Request for Information Response

RFI Number: R-AW071

ARAPAHO ROAD - PHASE III
 SURVEYOR BOULEVARD TO ADDISON ROAD
 PAVING PLAN AND PROFILE
 STA 75+00 TO STA 80+00

TOWN OF ADDISON, TEXAS

Design	JSN	Drawn	GFS	DATE	APRIL 04	SCALE	H: 1" = 20' V: 1" = 5'	PROJECT NO.	25769	SHEET NO.	PP-10
Check	JDH	Check	JSN

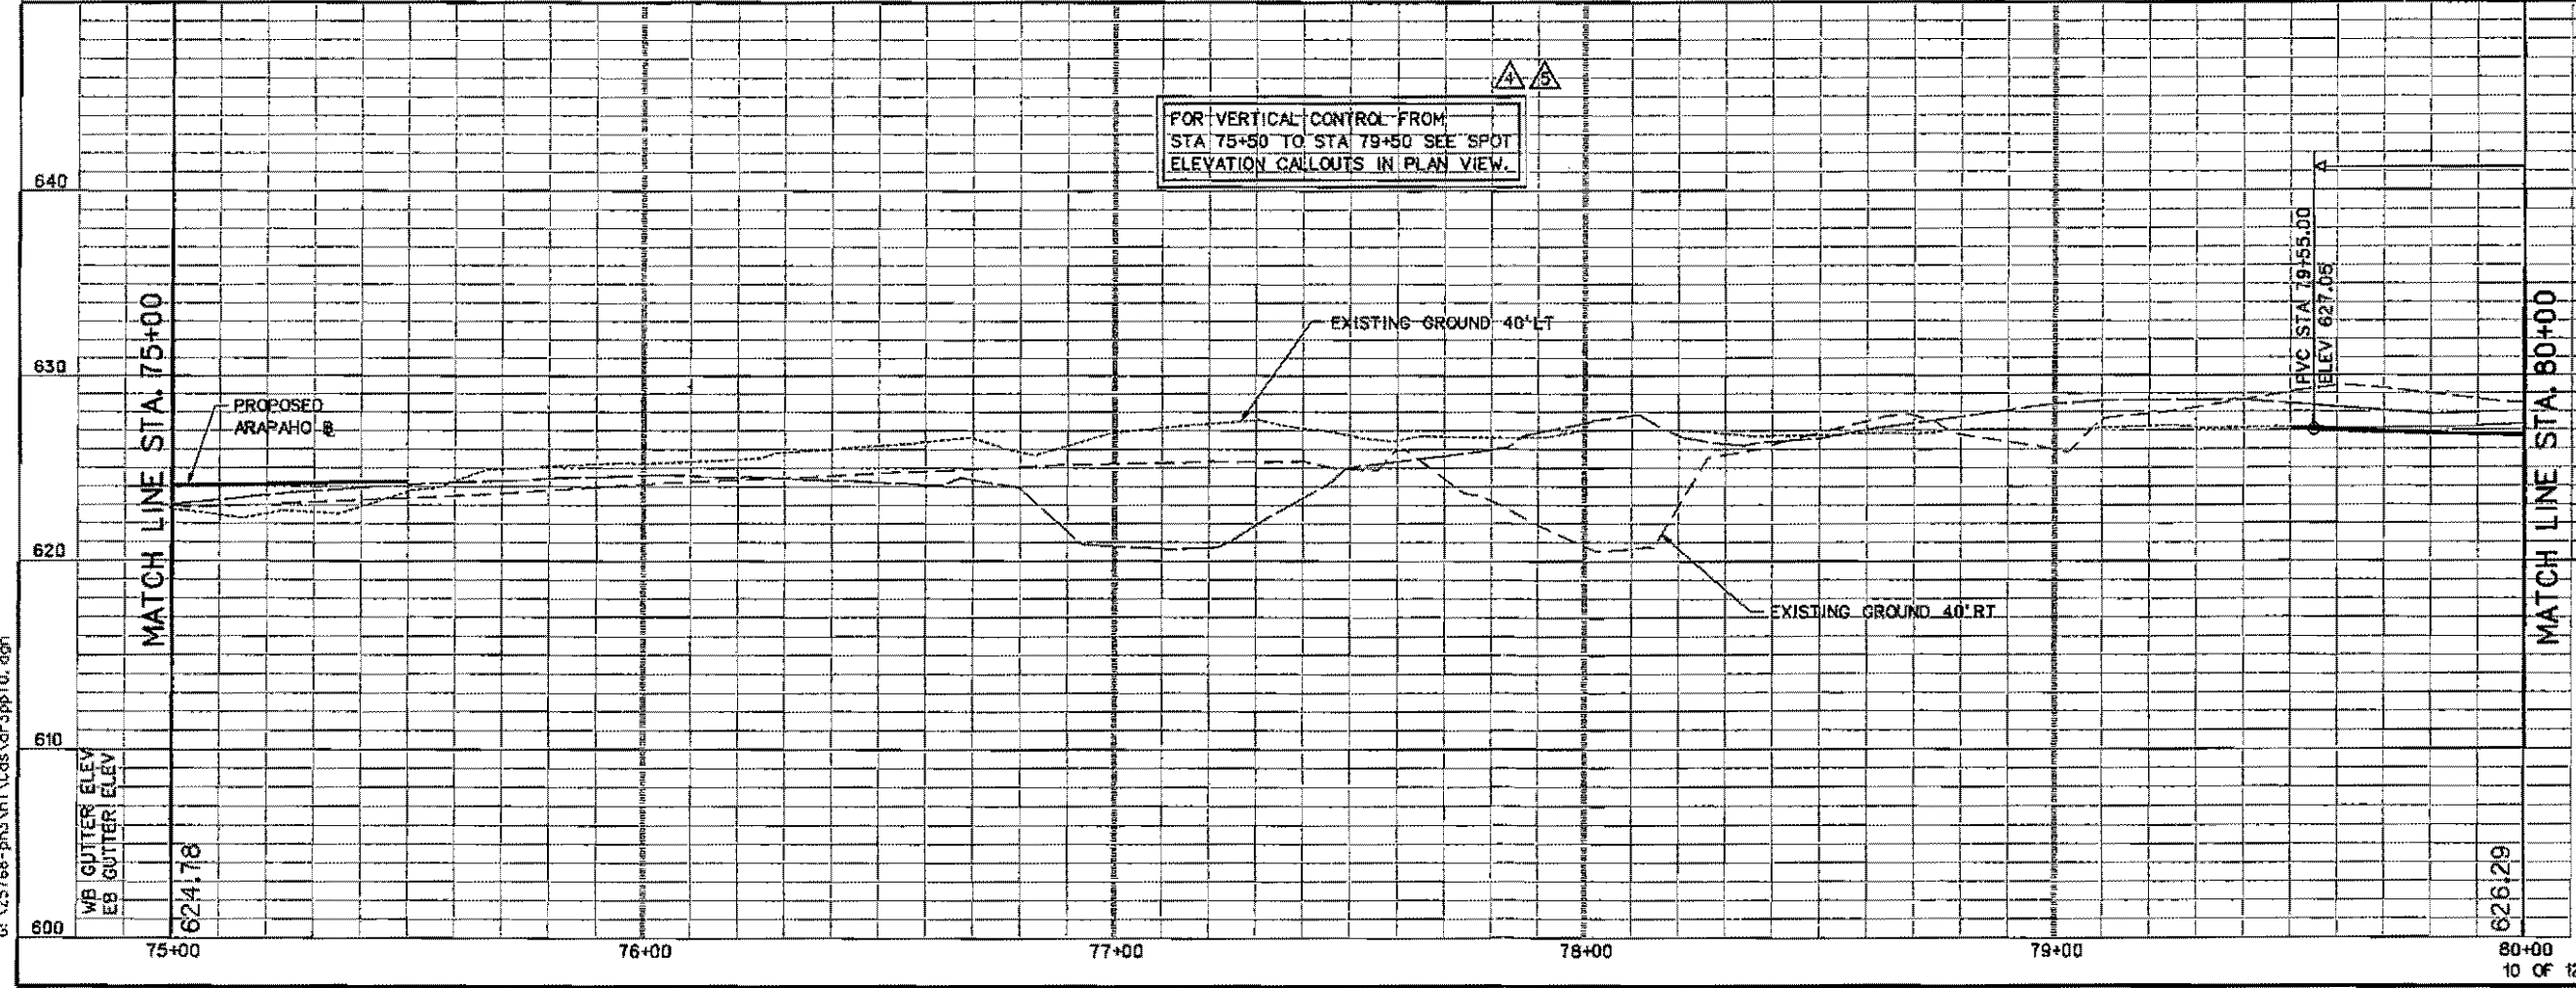
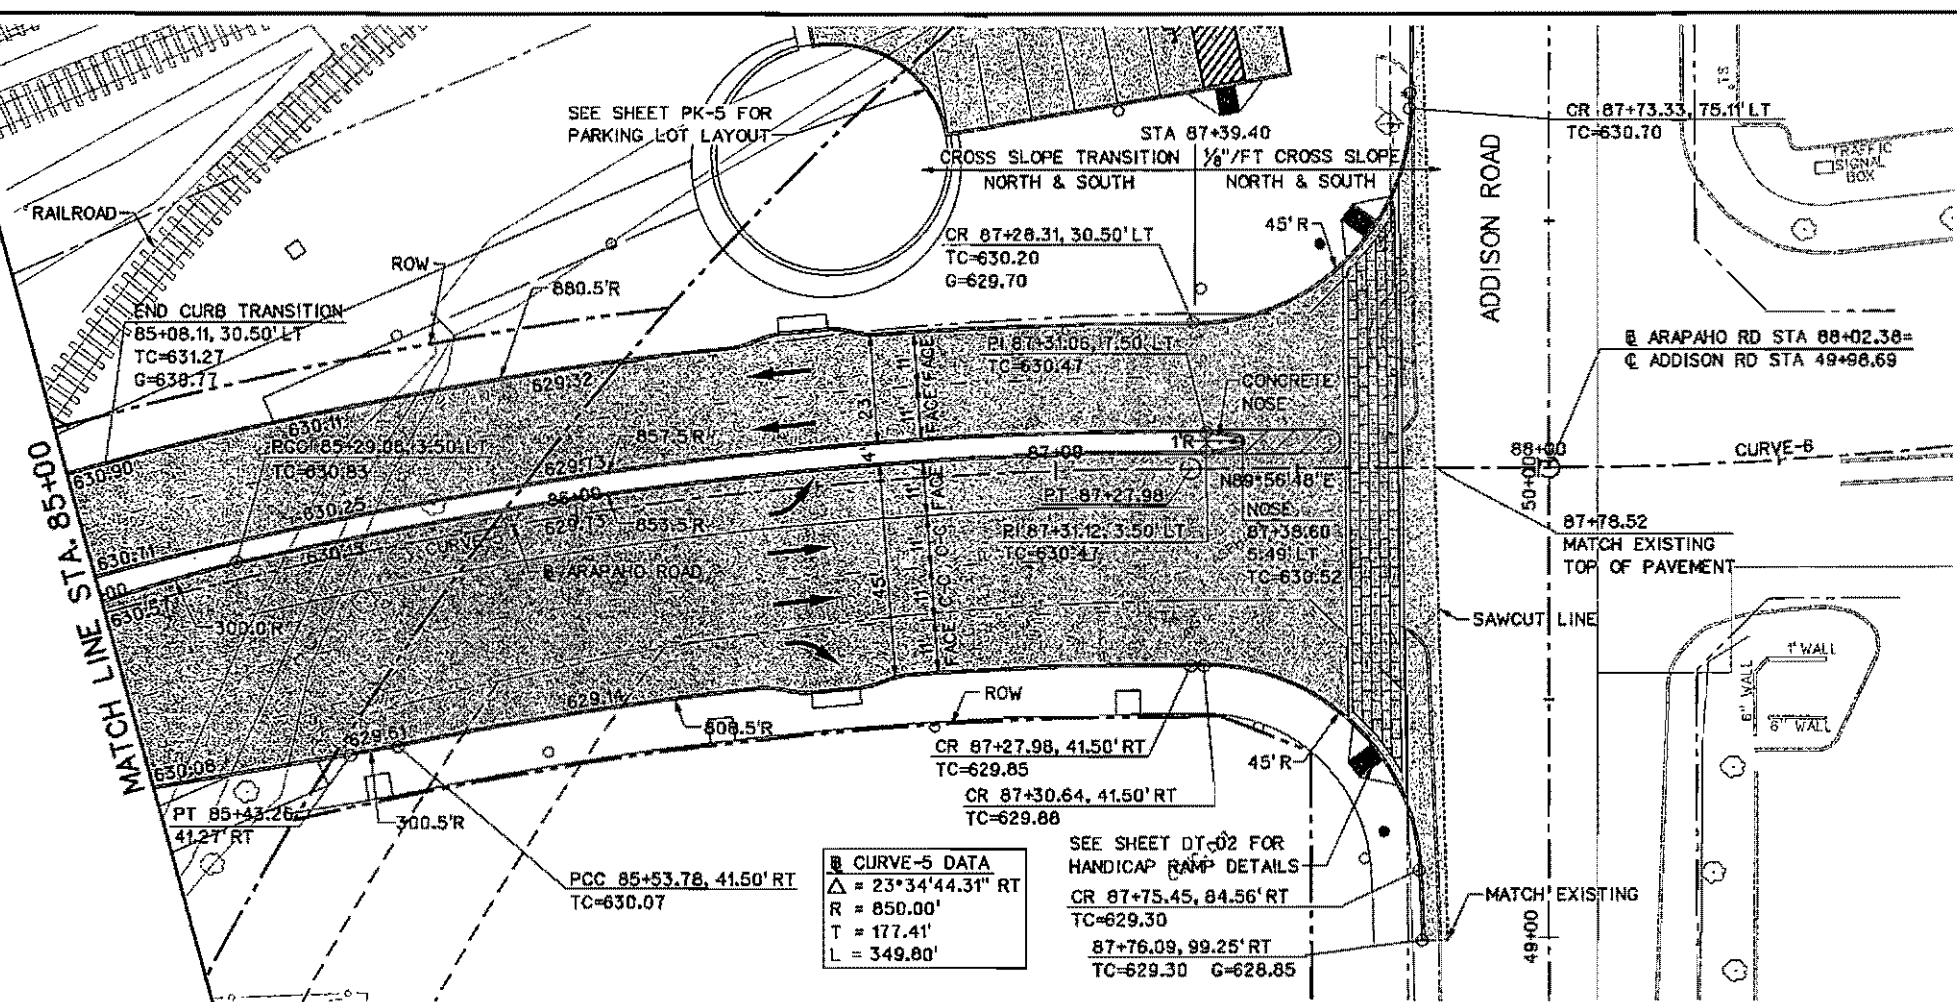
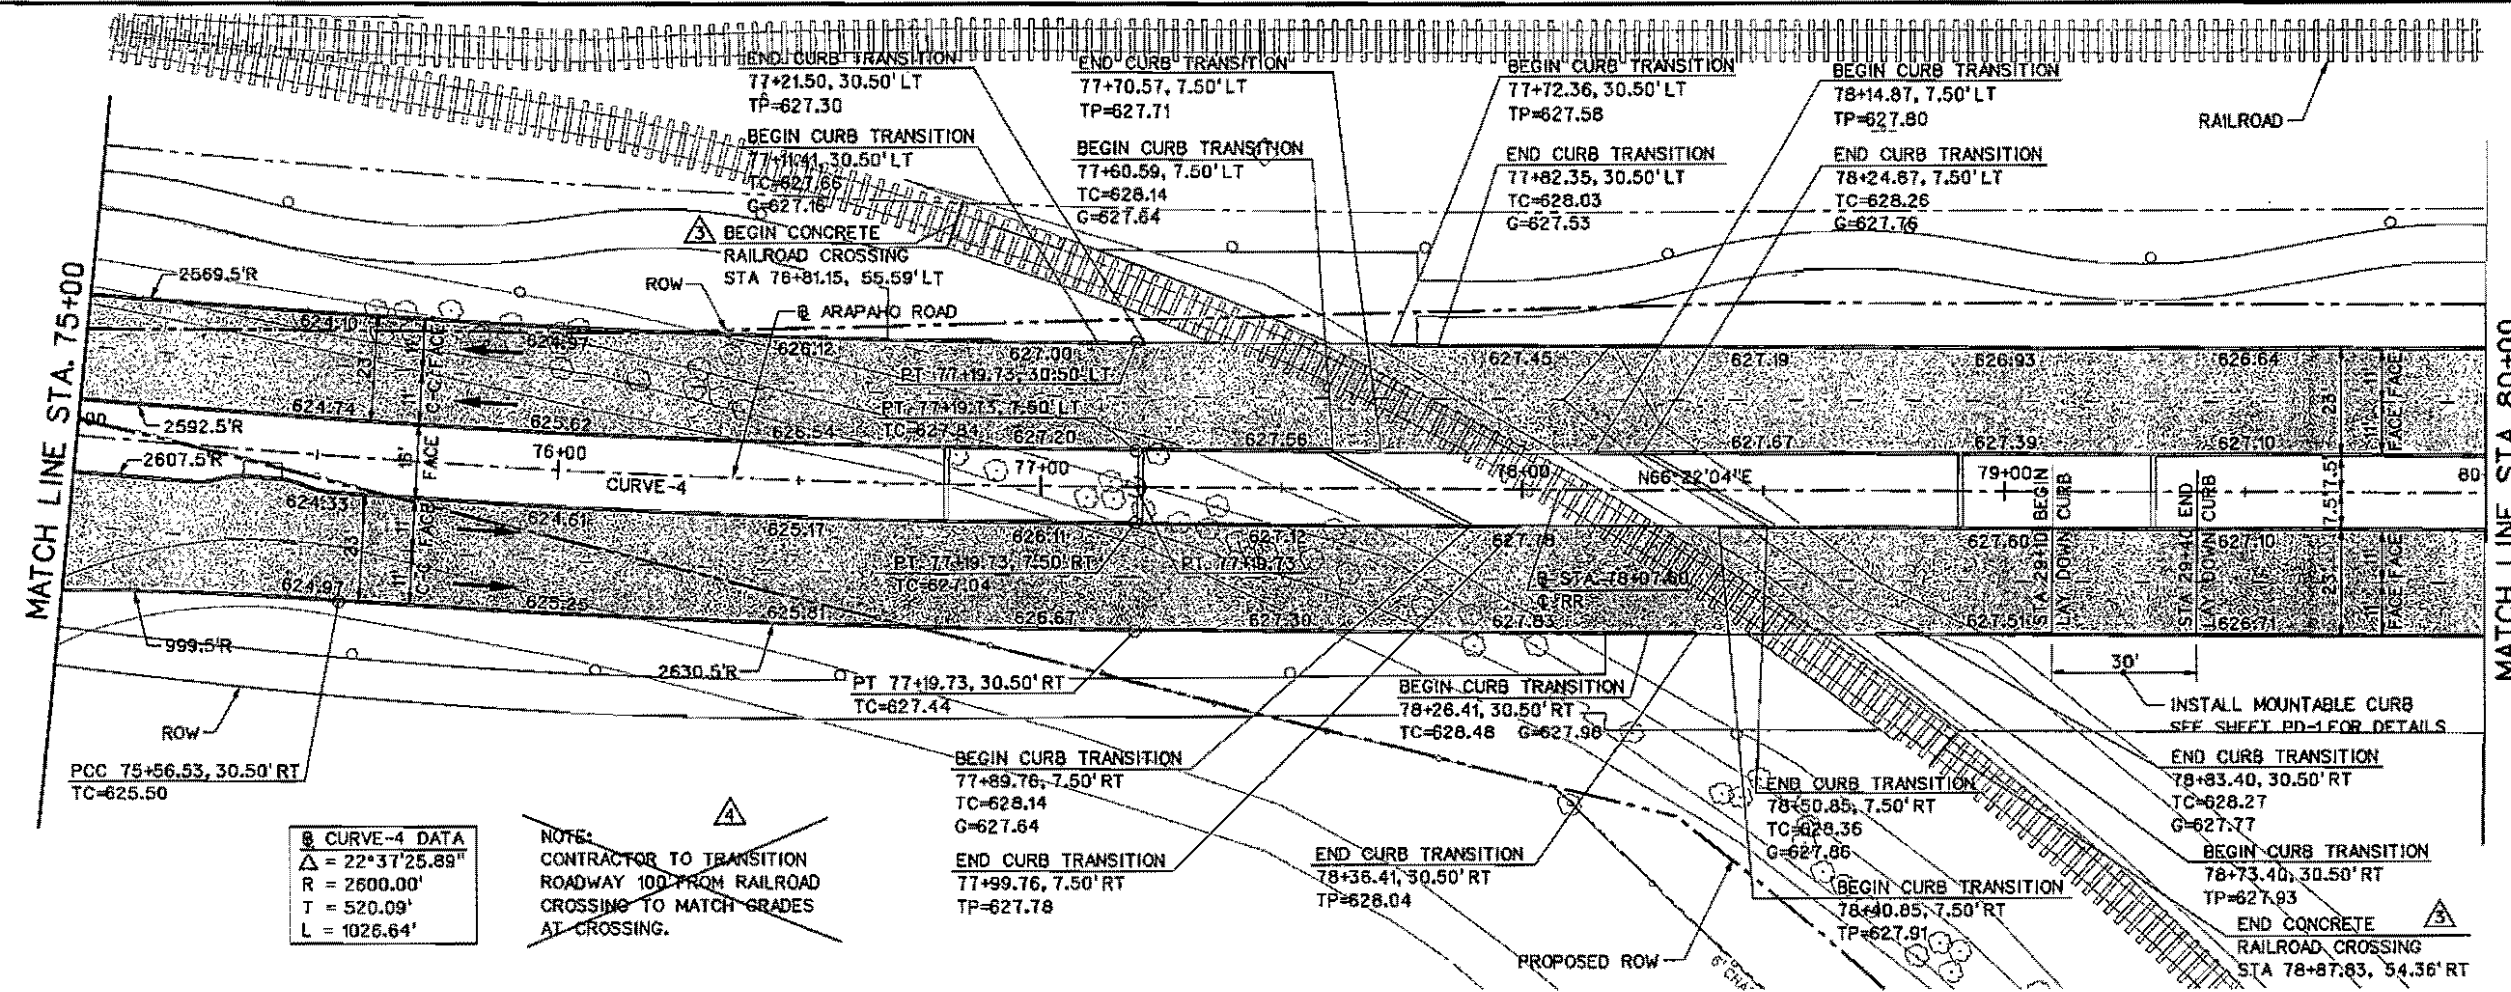
Request: Archer Western Contractors, Ltd. has reviewed the revised roadway profile grades in relation to the existing rail road crossing grades, and discovered that the revised grades project below the existing railroad crossing grades by as much as 4 inches in some areas.

Attached to this response are three contract drawing with the grade elevation shown along the roadway curb line. The information included on the plans should answer all questions above.

NO.	DATE	REVISION	APPROV.
5	2-24-05	REVISED GUTTER SPOT ELEVATIONS	WSF
4	1-17-05	REVISED GUTTER SPOT ELEVATIONS	JON
3	5-24-04	ADDED NOTES	JSN

Design JSH	Drawn GFS	DATE	SCALE	PROJECT NO.	SHEET NO.
Check JSH	Check JSH	APRIL 04	H: 1" = 20' V: 1" = 8'	25766	PP-12

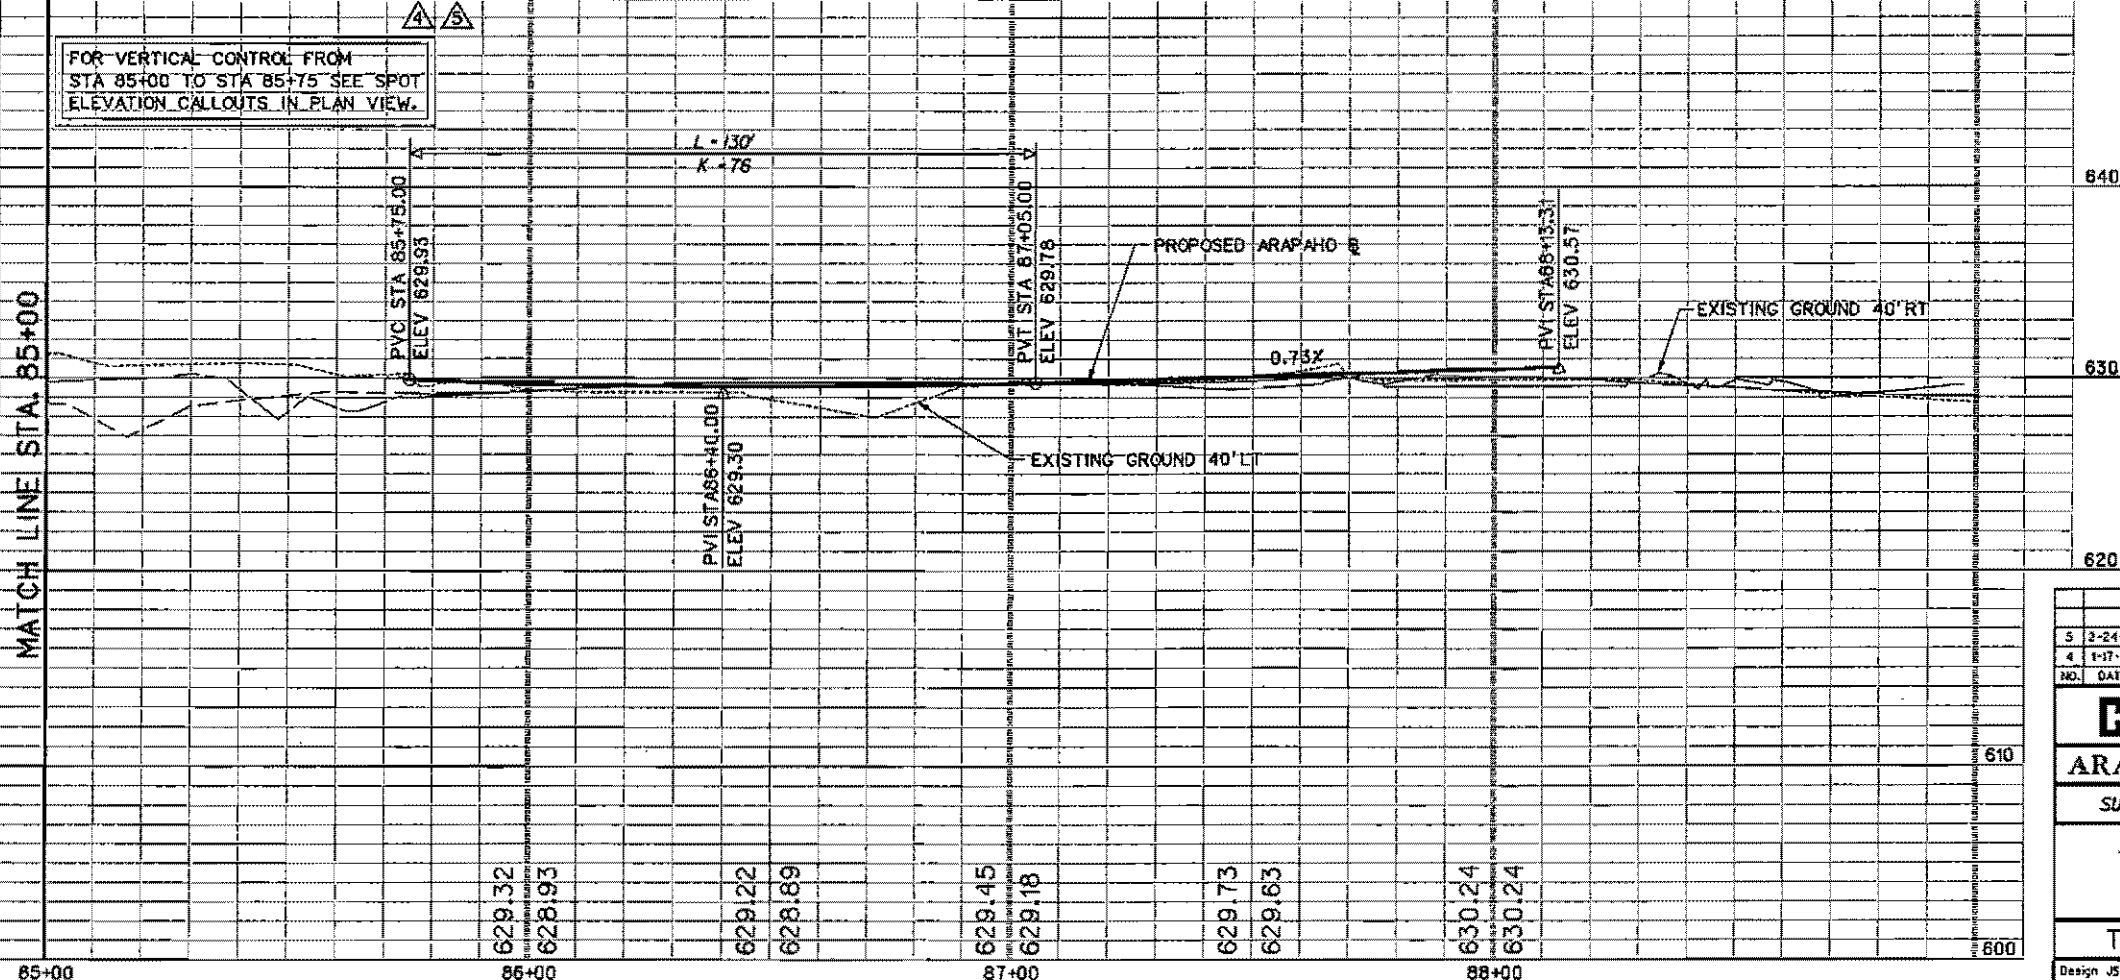
NO.	DATE	REVISION	APPROV.
5	2-24-05	REVISED GUTTER SPOT ELEVATIONS	WSF
4	1-17-05	REVISED GUTTER SPOT ELEVATIONS	JSH

Subject: Gas Main Conflict at Midway Rd.

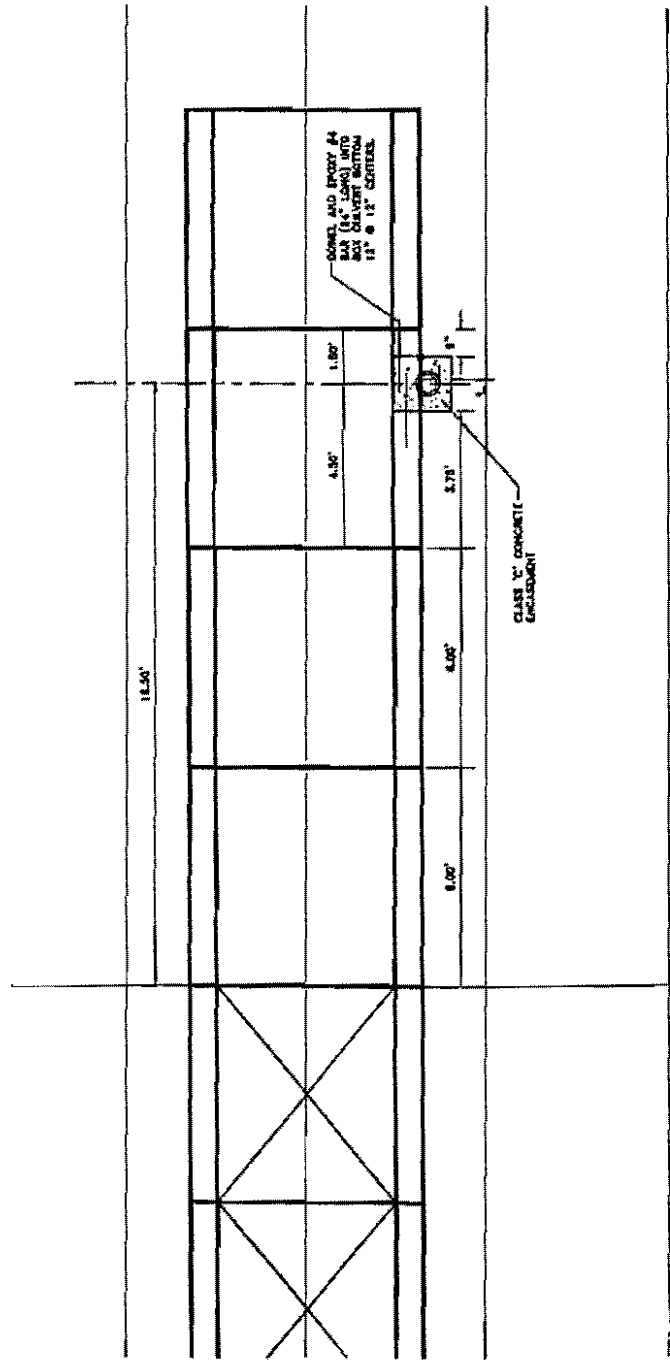
Request: Archer Western Contractors, Ltd. asking for solution to the conflict with the existing gas main and the existing concrete slab with the bottom of the Line A box culvert.

1. To clear the gas main, Archer Western Contractors, Ltd. is to remove a section of the bottom of the precast box culvert that will fall over the gas main and incorporate a concrete encasement around the gas main with the bottom of the precast box culvert. See attachments to this response with details and requirements for this work.
2. In the investigation of the concrete slab, it has been found that the original SBC phone duct was on the West side of Midway rd. The concrete slab is a protect cover for the old abandon conduit ductbank. Therefore, Archer Western Contractors, Ltd. may remove the existing concrete slab over the ductbank, but to allowed damage the old abandon conduits below.
